## ADDENDUM NO. 9

PROJECT: NEW FIRE STATION #27  
COSA, San Antonio, TX

DATE: December 13, 2010

11/A13.2

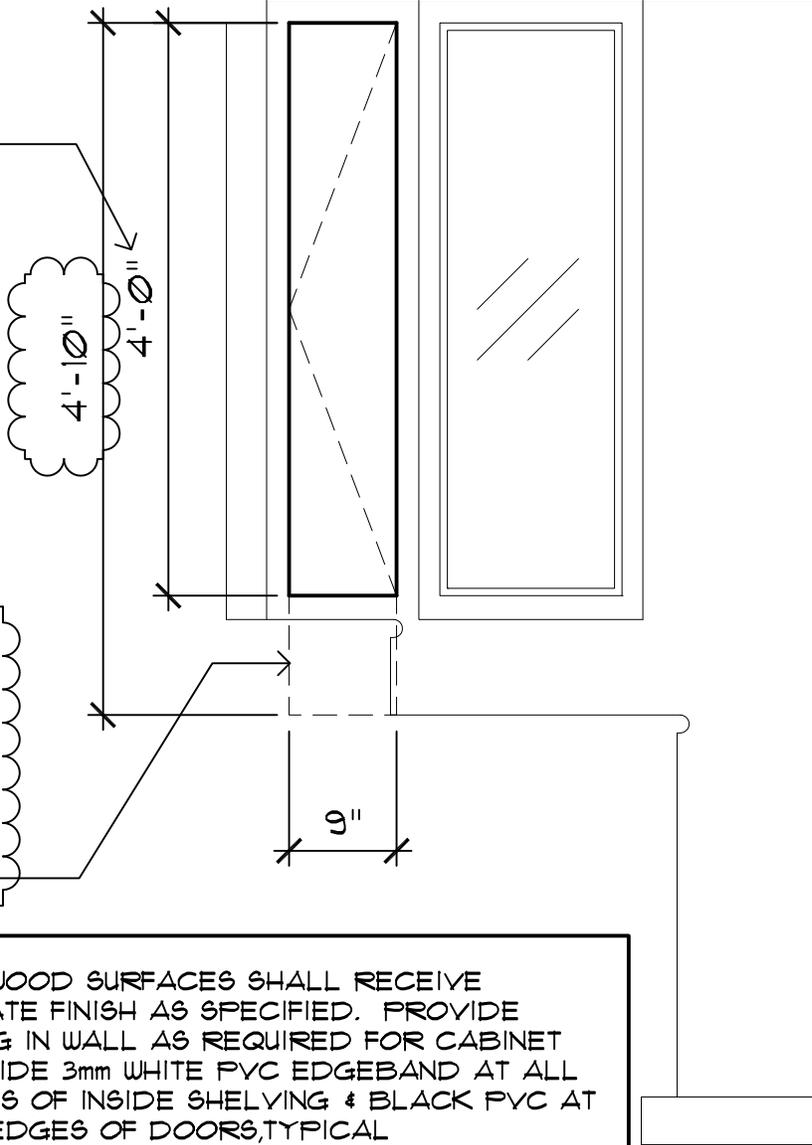
- A. **Revise** detail #11 in accordance with **Attachment “B”** (1 sheet: 1 of 1), which includes clarification of the wire manager raceway cavity dimensions.
- B. **Add** the details (#12 & #13) included on **Attachment “C”** (2 sheets: 6 of 7 & 7 of 7), which consist of section cuts through the EMS bay closets.

5/A12.2

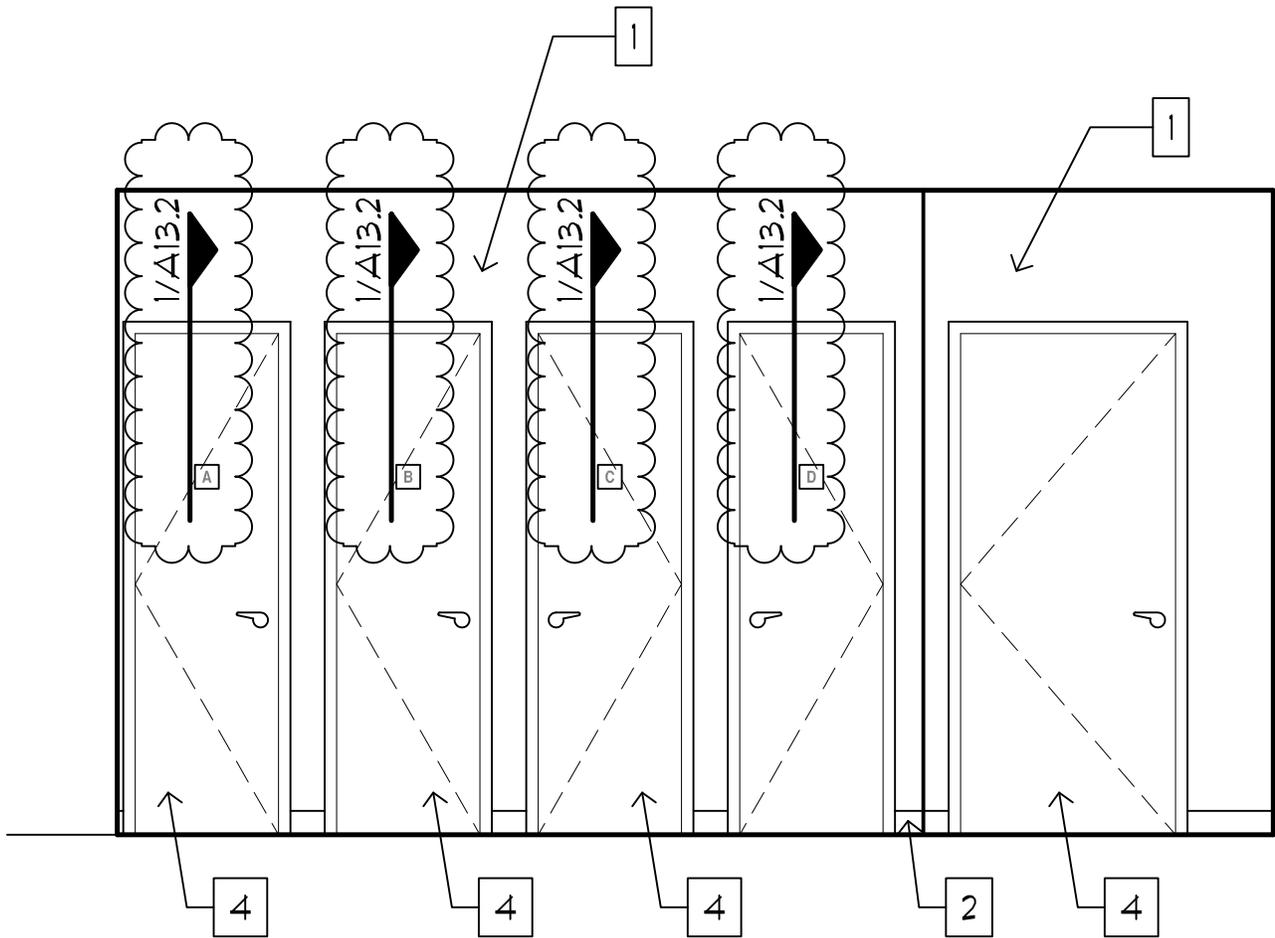
- A. **Add** detail references for Details #5, #6, and #9 as shown on **Attachment “C”** (3 sheets: 1 of 7, 2 of 7 & 3 of 7). The detail references are for closet millwork section cuts.
- B. **Revise** Keynote #18 to read, “Provide Continuous Full-Height, Type 304, 18 Gauge Stainless Steel Backsplash with Satin Finish.”

6/A12.3

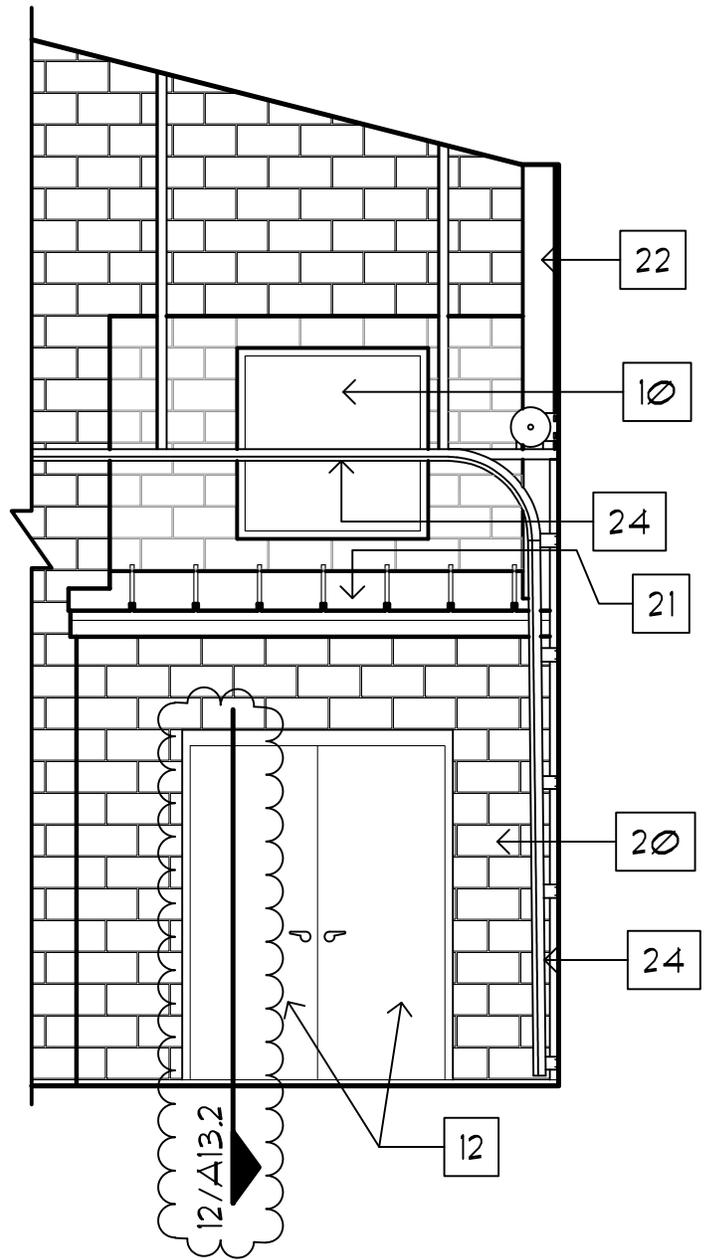
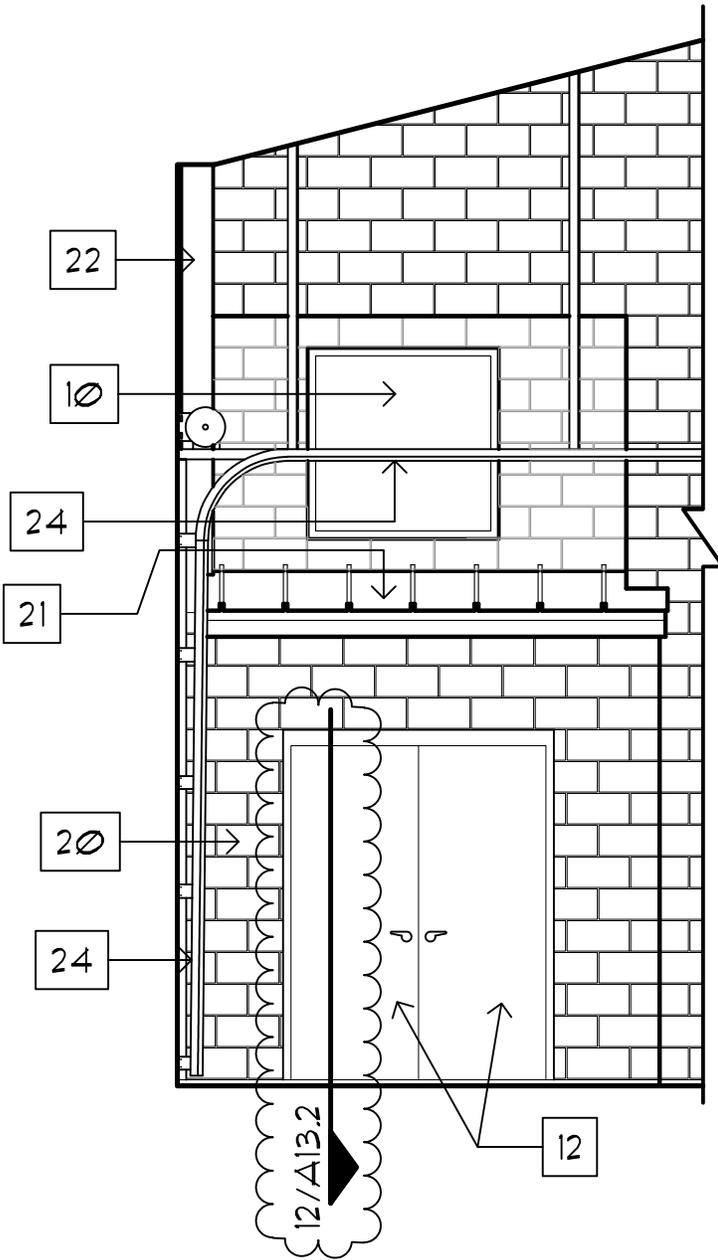
- A. **Add** detail references for Details #4 and #6 as shown on **Attachment “C”** (2 sheets: 4 of 7 & 5 of 7). The detail references are for closet millwork section cuts.

1/A7.7

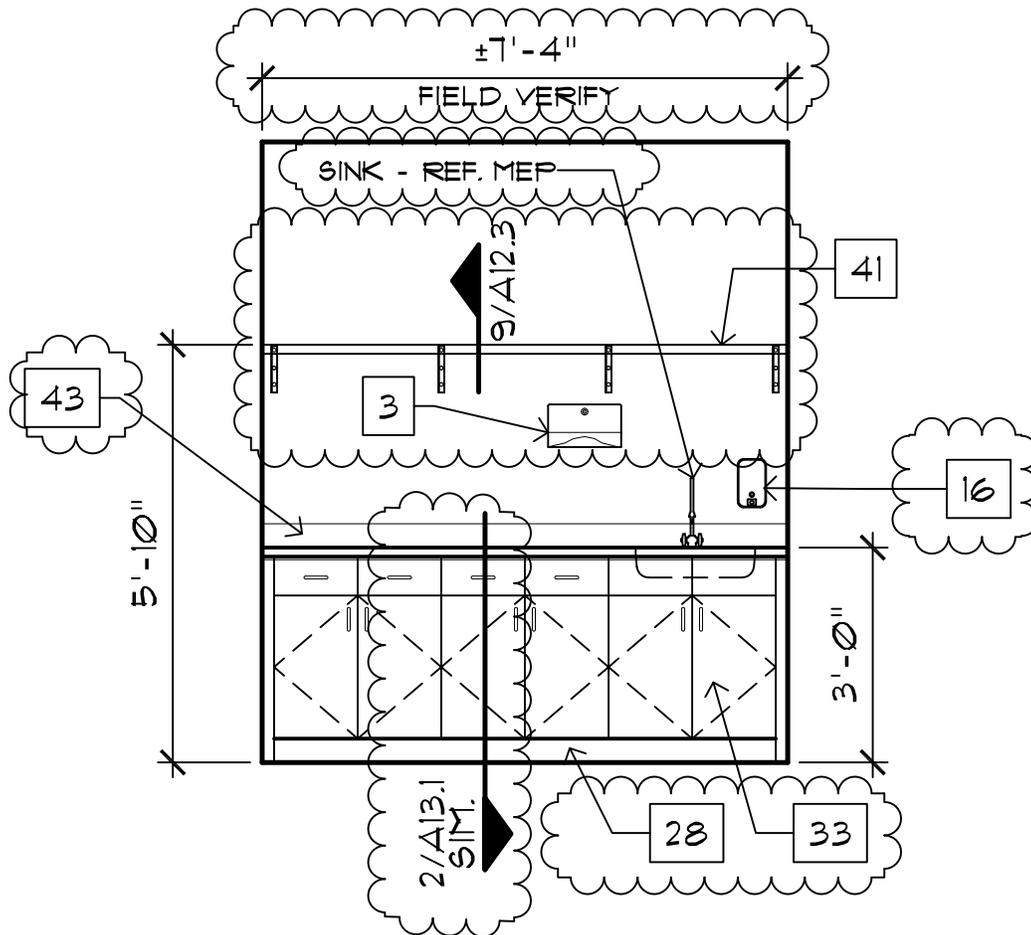
- A. **Revise** Detail #1 – “Interior Panel Sign Schedule” in accordance with **Attachment “D”** (1 sheet: 1 of 1); some of the missing sign quantities have been clarified.

5/A12.4

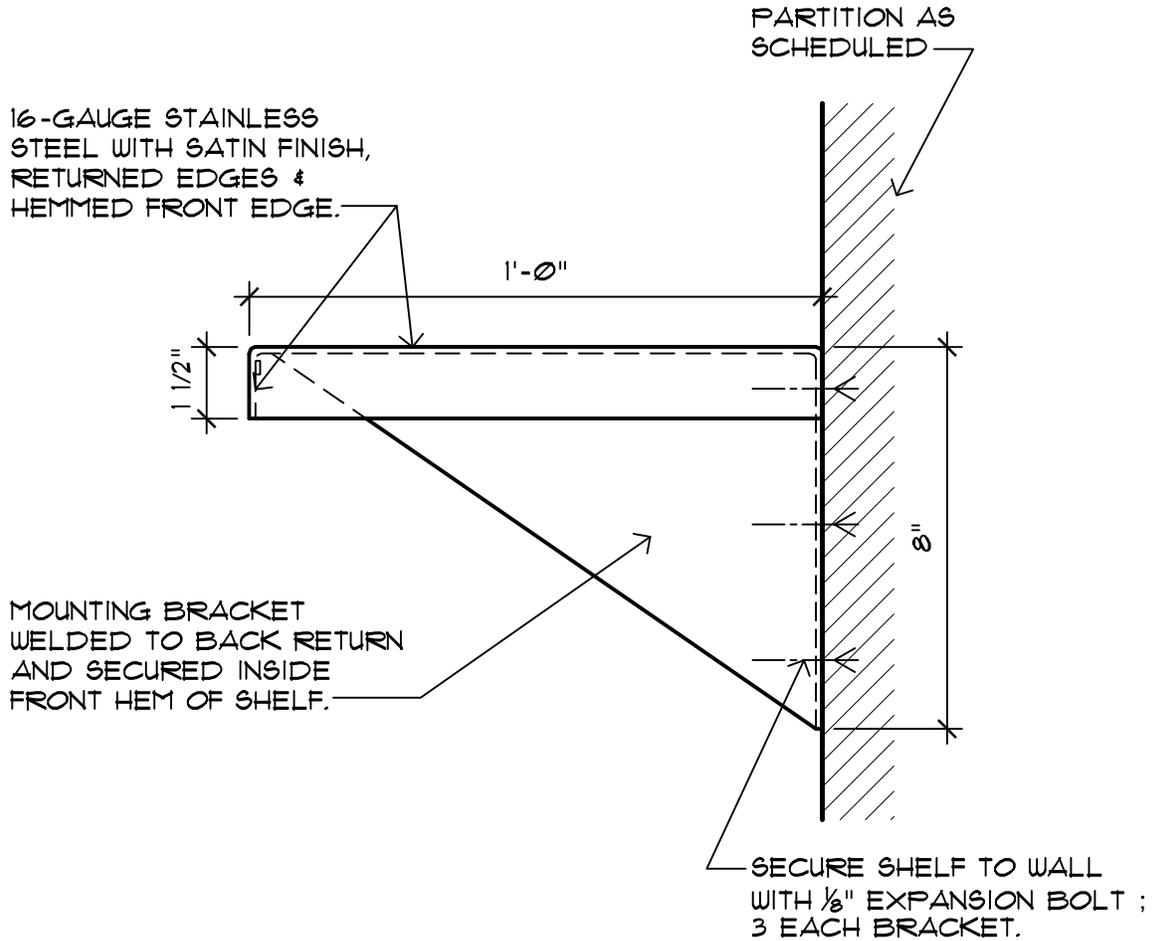
- A. **Revise** Keynote #41 to read, “Shop Fabricated, Type 304, 16 Gauge Stainless Steel Shelf with Satin Finish.” Refer to **Attachment “E”** (1 sheet: 2 of 3) for a section cut through the shelf.
- B. **Revise** Detail #5 in accordance with **Attachment “E”** (1 sheet: 1 of 3).
- C. **Revise** Detail #4 in accordance with **Attachment “F”** (1 sheet: 1 of 1).

43. PLASTIC LAMINATE ON 4" HIGH, 3/4" THICK PLYWOOD INTEGRAL BACK-SPLASH IN LIEU OF CONTINUOUS FULL-HEIGHT BACK-SPLASH ORIGINALLY REFERENCED IN DETAIL 2/A13.1.

**1/A7.1 AND 4/A7.1**

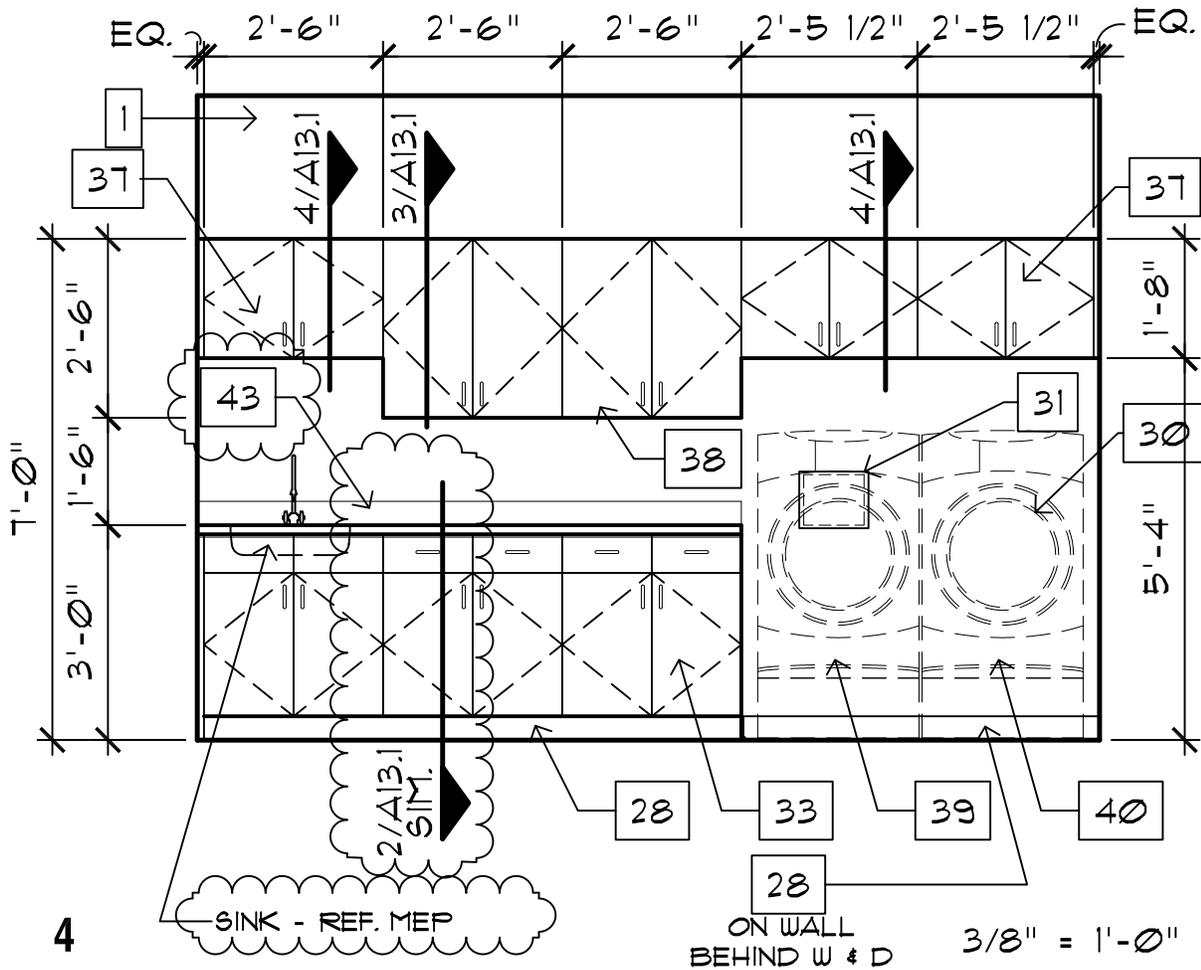
- B. **Revise** Detail #1 & Detail #4 in accordance with **Attachment “E”** (1 sheet: 3 of 3), which includes revisions to the wall-base in Wash Room #186.

F. PROVIDE RUBBER WALL BASE AS SPECIFIED ONLY AT THE TOE KICK FOR THE CABINETS ALONG THE WEST WALL IN WASH ROOM 186.
